ENGINEERING CLOSURE REPORT
BIG ISLAND MINING (XAT-7)
AND
ATCHAFALAYA SEDIMENT DELIVERY (PAT-2)

AS-BUILT CONSTRUCTION PHASE

DECEMBER 1998

Appendix	A	Project Field Changes
Appendix	B	Project Dedication Ceremony
Appendix	C	Benchmarks on BIM and ASD
Appendix	D	Surveys
Appendix	E	As Built Channels and Disposal Areas

FIELD CHANGE NO. 4 - DRAWING NO. 5

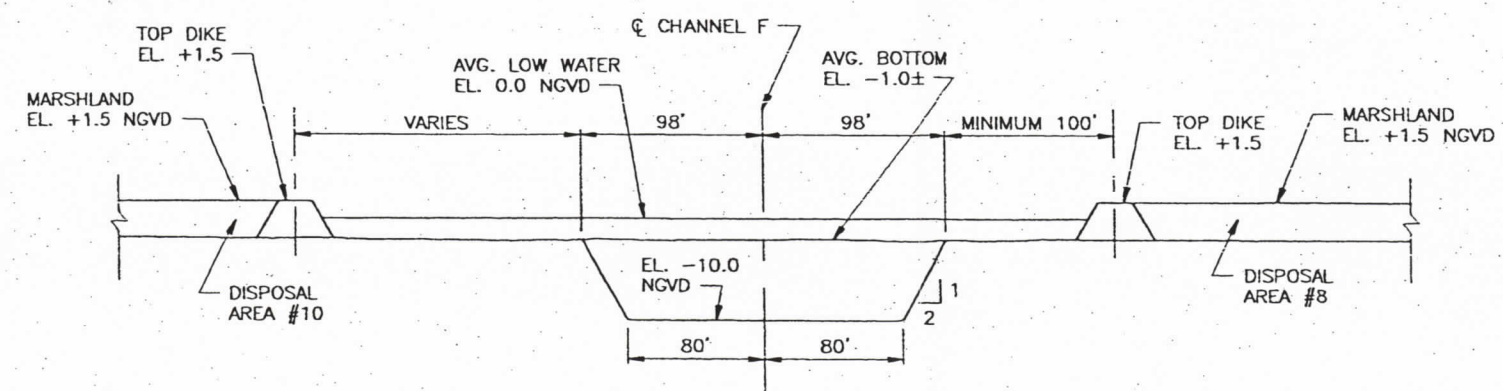
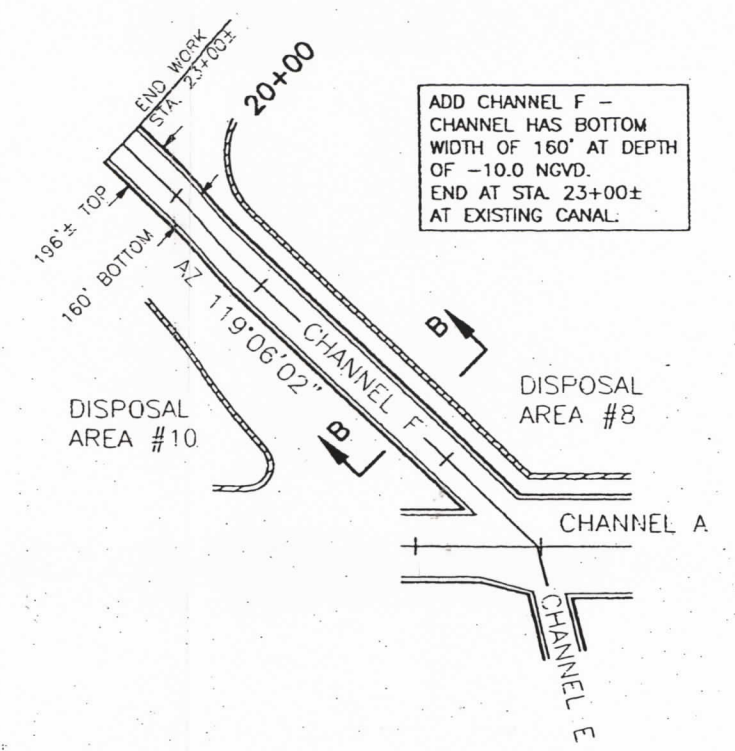
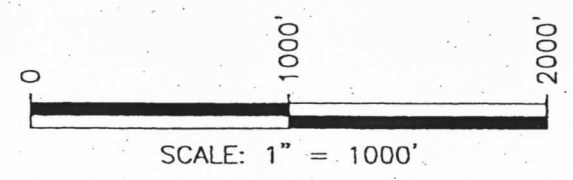
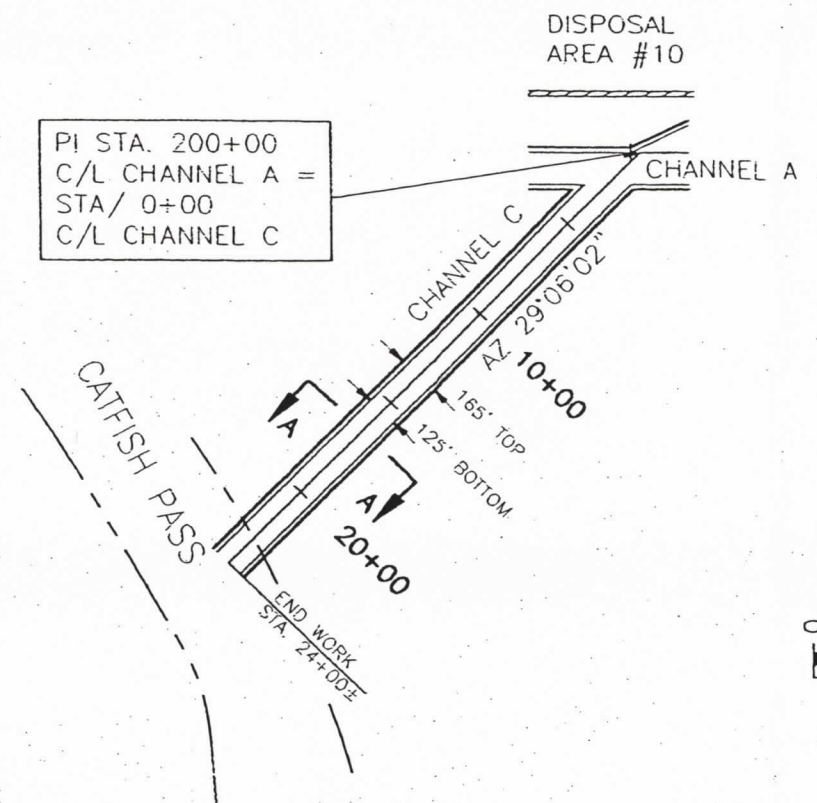
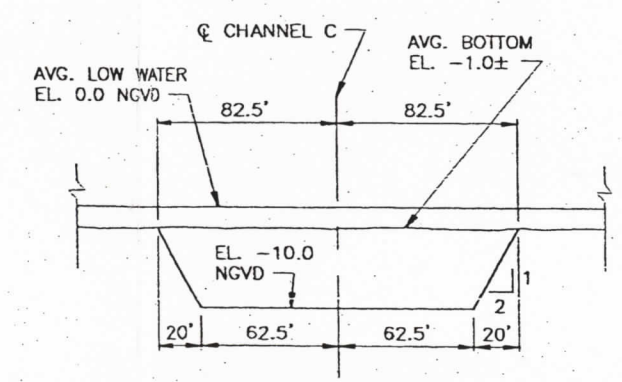
In addition, add new Channel F starting at station 180+00 of Channel A and extending on an azimuth of 119° 06' 02" to station 22+00± to intersect with the existing pipeline canal. Channel F shall have a bottom width of 160 feet to -10.0 NGVD. Also, extend the Disposal Area No. 8 dike along new Channel F with the bucket dredge to station 20+00 of Channel F. Contractor shall conduct a magnetometer survey prior to doing work along Channel F to insure that no pipelines exist.
